2014 - 2016 Corvette: Service Bulletin: #17-NA-278: Convertible Top Creak or Snap Noise While Driving

#17-NA-278: Convertible Top Creak or Snap Noise While Driving - (Aug 29, 2017)

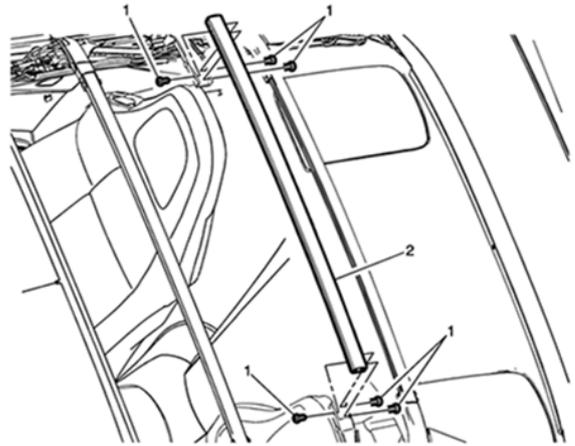
The cause of the condition may be that the fasteners (1) at the ends of the #3 Bow (2) may have lost torque.

Following the Service Procedure below, remove the original smaller screws and install the new larger M6 screws referenced in the Part Table.

1. Starting on either side, replace the current M5 retaining screws with the new M6 self threading screws.

Tighten the screws to 3 Y (27 lb in).
